**City of Issaquah
Development Services Department
Administrative Site Development Permit**

NOTICE OF DECISION

SUBJECT: Administrative Site Development Permit (ASDP) for Block 4 of the Issaquah Highlands

FILE NO.: ASDP18-00004

WESTRIDGE BLOCK 4: AMENITIES & PARKING

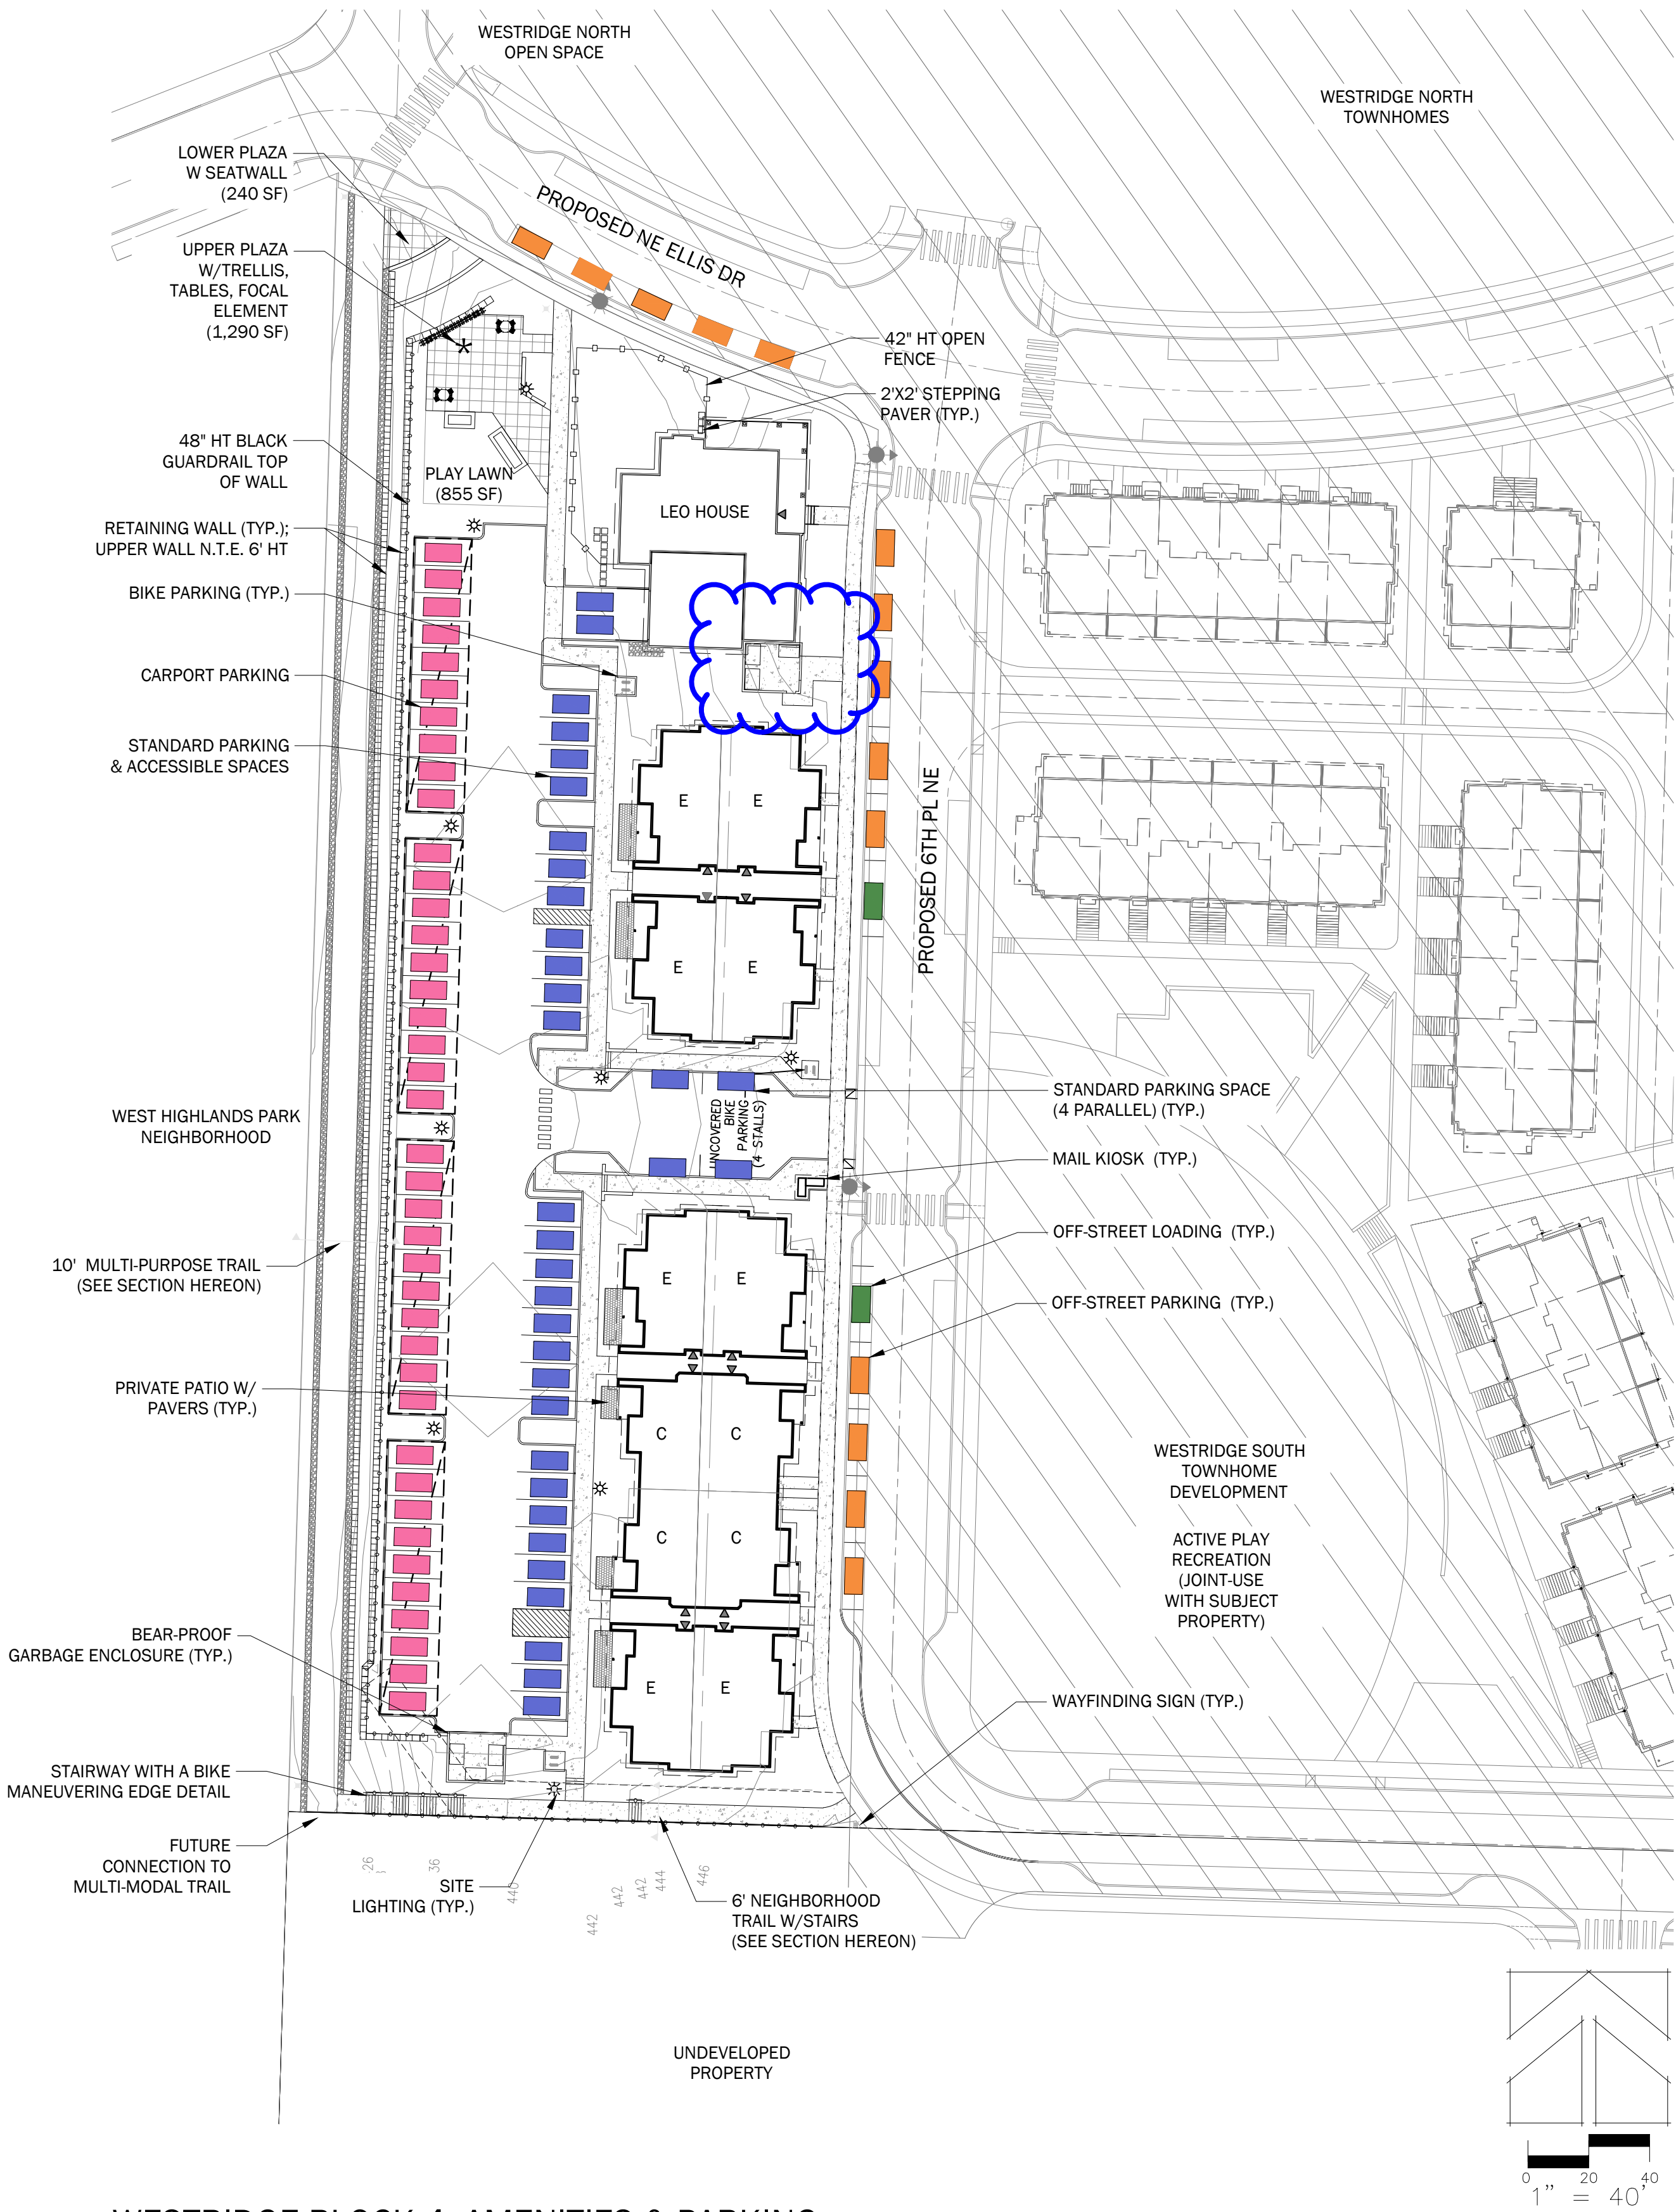
- The parking lot must provide one tree for every 6 parking stalls. At a minimum, the site must provide approximately 13 trees. The current proposal shows only 12 trees within the parking lot.

31. The site plan shows two parking stalls being offered in the driveway of the LEO House. At a minimum, the group home must provide approximately 4 on-site parking stalls to meet the parking requirement. Parking will be reviewed during construction permits.
32. Approximately 6 bicycle spaces shall be provided based on the number of vehicular parking required. This will be reviewed with the construction permits.
33. Covered bicycle parking is being shown to the east of the waste receptacle. No details on the material or design was provided. Prior to installation the applicant must receive joint approval from the ARC and the City. Providing bicycle parking within the atriums of the buildings as well as on the site is highly recommended.

36. No information regarding height, materials, or design was provided for the carport. The carport design must be designed to the Traditional Townscape Neighborhood style and resemble the condominium buildings' architecture and color. Examples of Traditional Townscape carports are shown below.

SECTION: MULTI-PURPOSE TRAIL

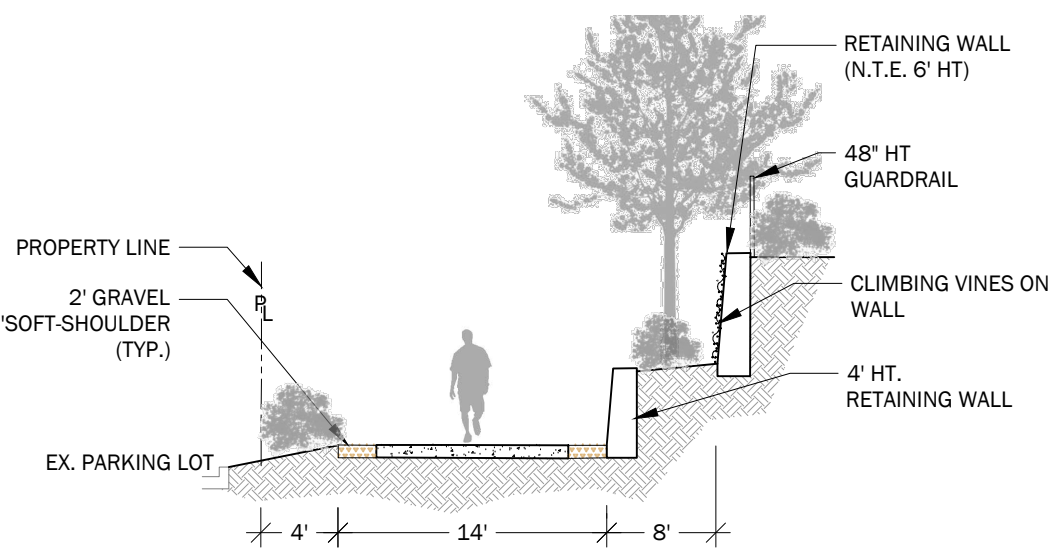
23. The current proposal shows two terracing retaining walls along the east side of the Multi-Purpose Trail. For a better pedestrian experience and so utilities can be easily accessible for future maintenance purposes, one of the retaining walls shall be relocated to the west side of the trail. The new layout will be reviewed during construction permits.
24. The Neighborhood Trail along the south end of the project must have a 4-foot wide landscape border on both sides of the trail.

25. The Neighborhood Trail must be 6-feet wide clear of obstructions, including the bike ramp and railing. A bike ramp or railing must be present along trail stairways.
26. Pedestrian signs identifying the presence of the Multi-Purpose Trail must be installed at trail entrances and key decision points along the trail. A plan showing the sign designs and locations along walkways must be submitted to the City for review and approval.
27. No callouts identifying the material for the Multi-Purpose Trail was provided. The trail must be constructed out of asphalt, concrete, or special paving.
